Summary: It has come to our attention that smoke may escape through the adjustment slots for the Load Door and also the Ash Door of the **Scandtec Solo Plus 30, 40 and 60** wood fired boilers. There are four of these adjustment slots for each door. This problem can be eliminated by installing the enclosed washers and following the instructions below.

Photo 1

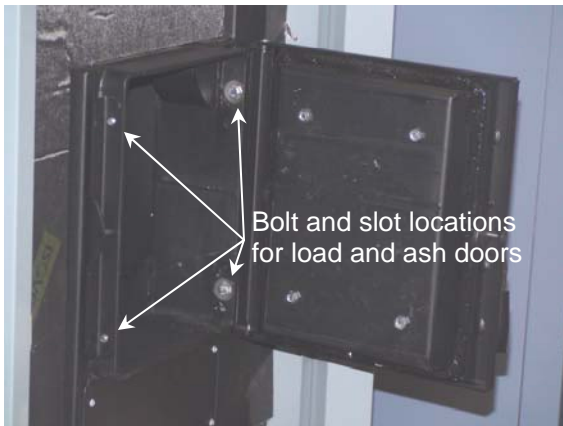
Action: With the boiler shut down and cool, open the load door and locate the four load door adjustment bolts just inside of the door frame (See Photo 1). You may note that the adjustment slots extend beyond the diameter of the bolt head. Smoke may escape from these slot gaps.

Remove one bolt at a time, add the one of the enclosed washers to the bolt, reattach the bolt and tighten. The flat on the washer is to provide a proper fit up against the rope gasket on the door when the bolt is adjusted toward the front of the boiler, or the flat should provide a proper fit up against the rear of the door frame when the bolt is adjusted toward the rear of the boiler (See Photo 2). This bolt and washer set will cover the slot gaps which will prevent smoke from escaping. We recommend you remove only one bolt at a time so you will not lose the adjustment of the door on the door frame. Repeat the above for the Ash Door. Recheck the seal adjustments of both doors.
